From: Neil Duffield
Sent: 15 February 2021 17:40
To: Helen Webster
Subject: NYM/2020/1006/FL & 1009/LB - Ingleby House E11947-25 NYMNPA revised window detail 15.02.21

Drawing for initial planning and client consideration only				
B A	15/02/21 14/12/20	CE nid		o show ex post. for approval
REV	DATE	BY	A	MENDMENT
Architecture + Engineering Airy Hill Manor, Waterstead Lane, Whitby, N. Yorks. YO21 1QB. P: +441947 604871 F: +441947 600010 E: general@bhdpartnership.com				
Messrs R & G Hodgson				
PROJECT: Ingleby House King Street Robin Hoods Bay YO22 4SH				
Drawing: Proposed Detail Sheet				
DRAWING STATUS: Preliminary				
DRAWN: CHECKED: NID				
SCALE @ SIZE: DATE: shown @ A1 14/12/20				
DRAWING NO: D11947-03 REV: B

window plan Scale 1:20

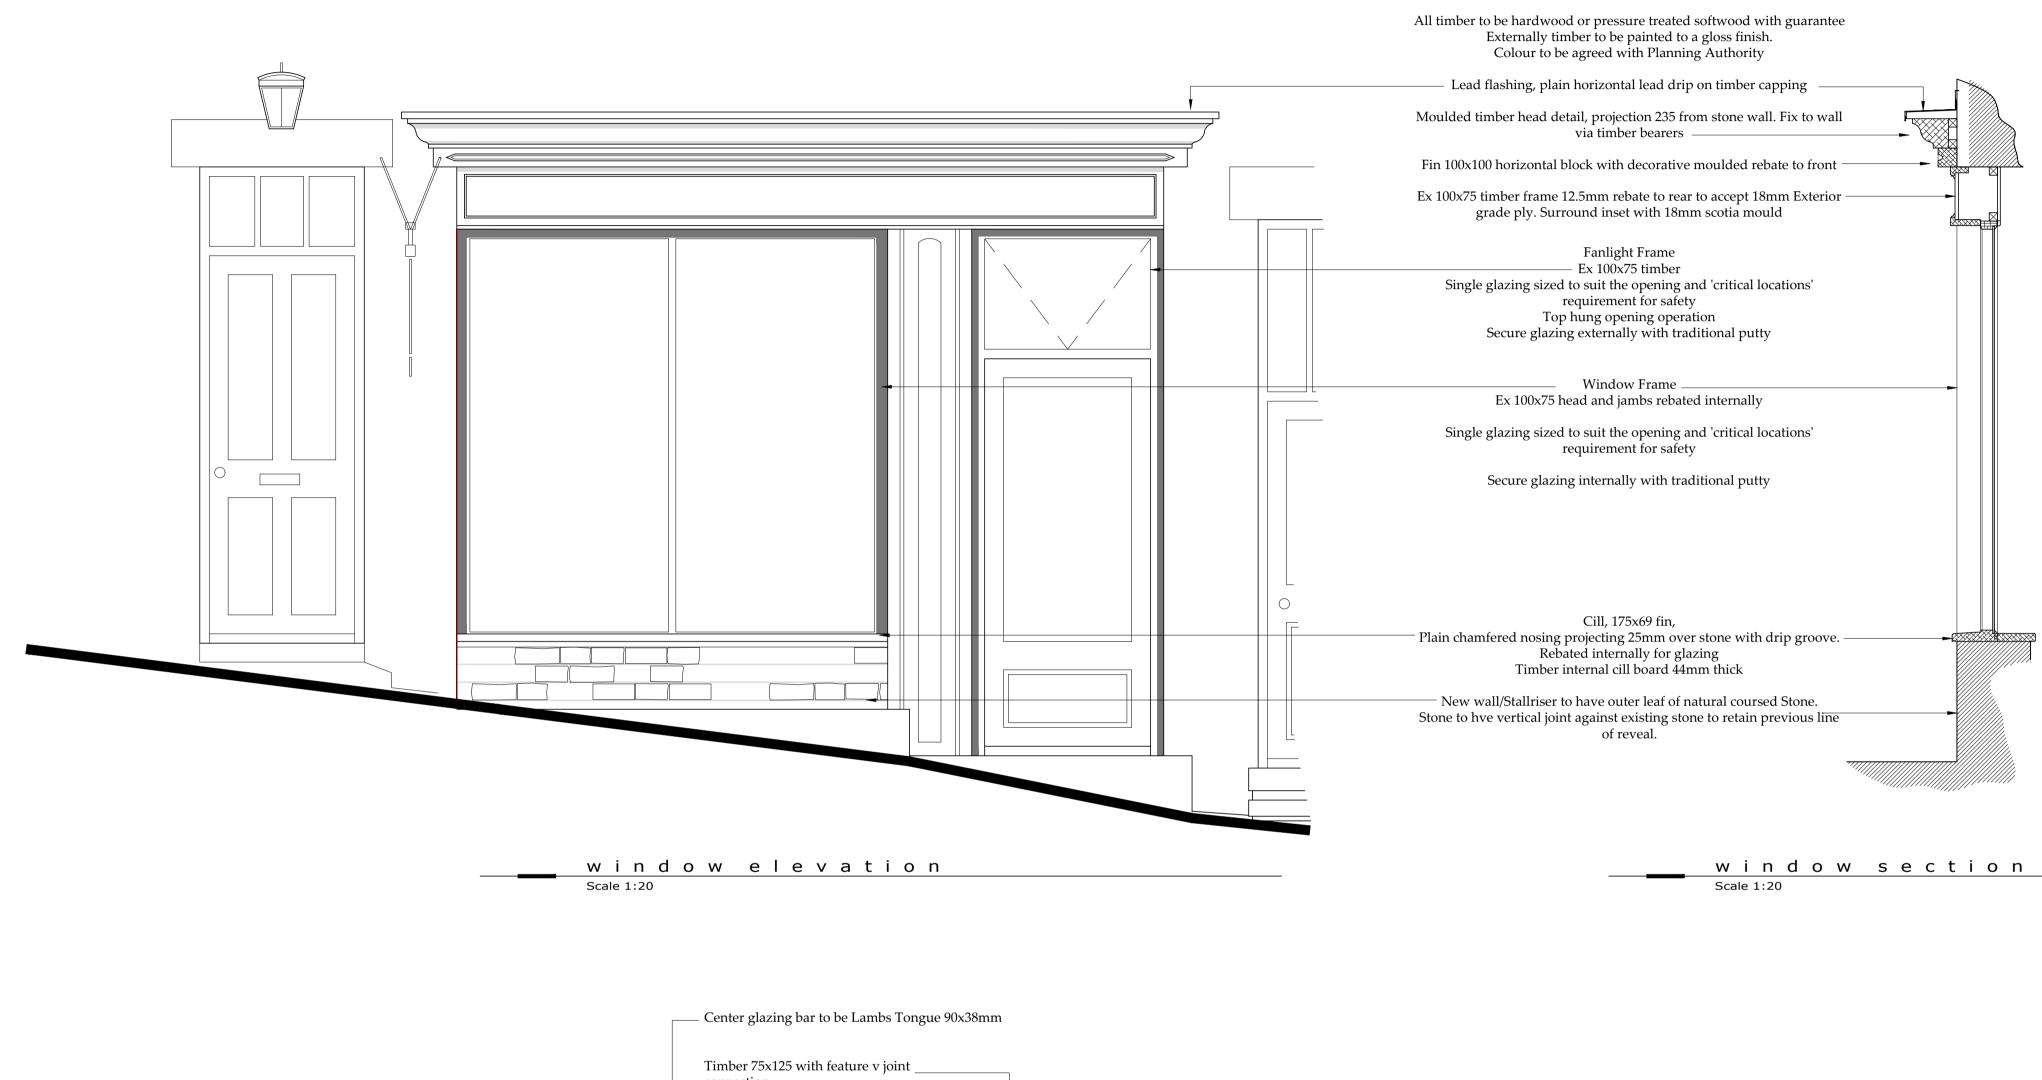
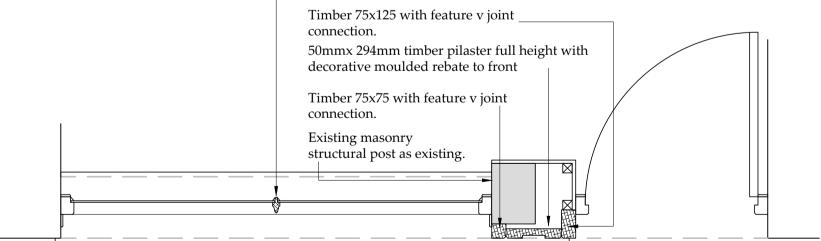
On the drawing the window is now set 125mm in reveal. Also we have had to amend the intermediate pilaster as our clients have discovered that the masonry pillar is an integral part of the original structural support.
